Work Order ID 150806

Item Name: Mounting Lug

DRAWING NO.	D2731	REV. C	DART AEROSPACE USA, INC	D.E.O. NO.	D2731-C-1	SHEET NO.	SHEET 1 OF 1	SCALE	NTS
TITLE	MOUNTING LUG	ENGINEERING ORDER							
DRAWN	SC	CHECKED	SC	MFG. APPR.	M	APPROVED	MD	DE APPR.	#
DATE	11.05.02	DATE	11.05.09	DATE	11.05.09	DATE	11.05.09	DATE	11.05.09

PURPOSE
ADD D2731-XRG OPTION

D2731-1RG MOUNTING LUG (SHOWN)
D2731-3RG/-5RG/-7RG MOUNTING LUGS (SIMILAR)

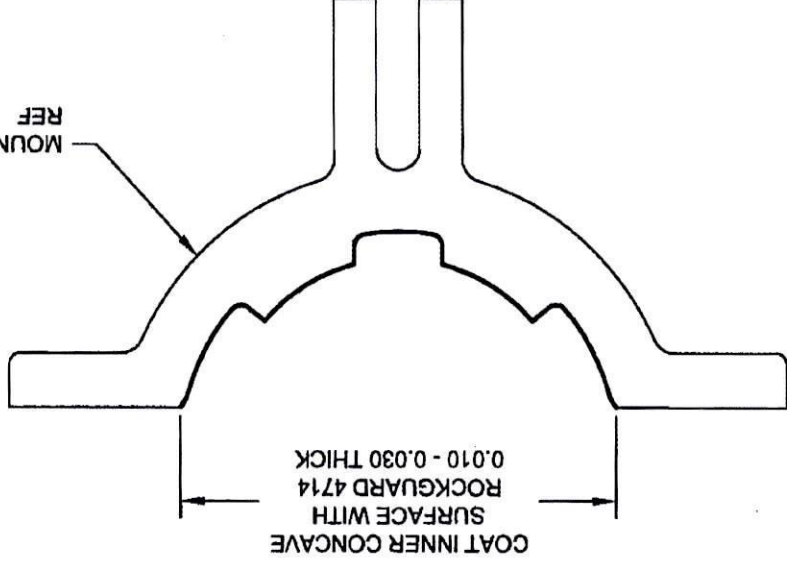
CHANGE
D2731-XRG MOUNTING LUGS ARE IDENTICAL TO D2731-X
MOUNTING LUGS, HOWEVER AFTER FINISH, COAT INNER
CONCAVE SURFACE WITH "PLUS ONE ROCKGUARD 4714"
AS SHOWN BELOW.
